Access Compliance Report Public Rights-of-Way (Curb Ramps)

Main Street: WILSON_ST Cross Street: MCFADDEN_AVE Location: NE

ADA ID: RPRK210930113857 Ramp Type: Type 1 - Perpendicular Diagonal Initial Pass/Fail: Fail Overall Compliance: No Severity Score: 32

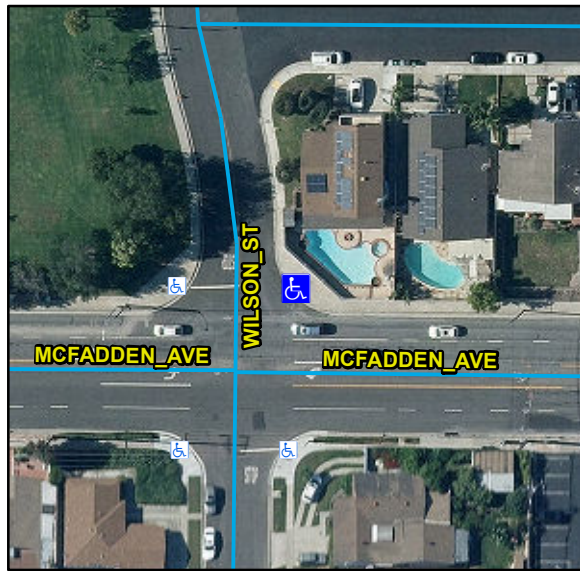
R304.2.2, R204.3, R304.5.3, STD 1115

Remove & Replace Curb Ramp With Two New Directional Ramps or Equivalent.
